Subject: **Bid #: 8479-J6, Great Brook Valley Park Improvements – Phase I / DPRC**

**ADDENDUM NO. 5**

**Date:** July 31, 2025  
**Project:** Great Brook Valley improvements  
City of Worcester Department of Parks, Recreation & Cemetery

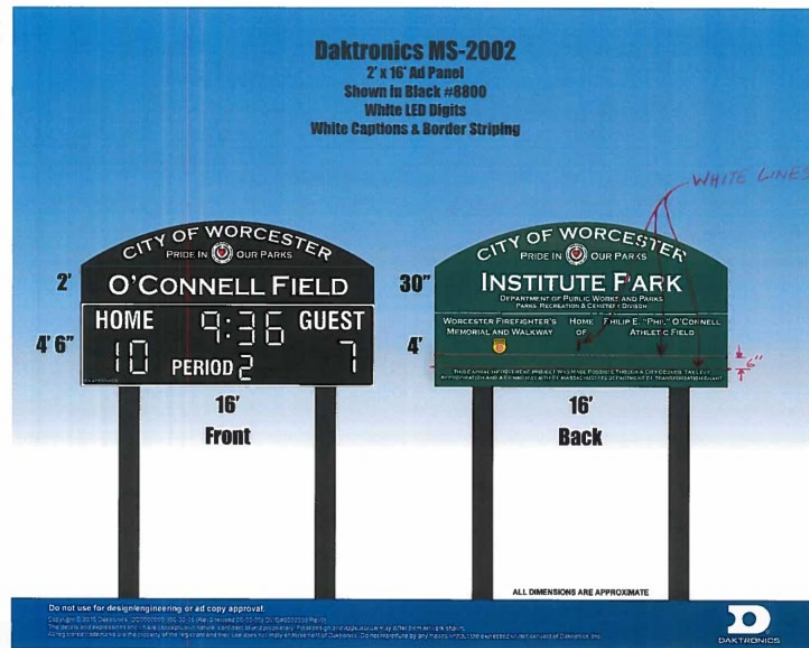
- i. Owner shall provide all necessary information for sizing, weight, and desired location of the park sign during the construction submittal process.
- ii. All necessary footing, post, anchor and connection point design, as well as dead load and wind load calculations shall be included as part of stamped engineers drawings from manufacturer.
- iii. The size of the back sign shall be full dimensions of the front sign. See image below for reference.
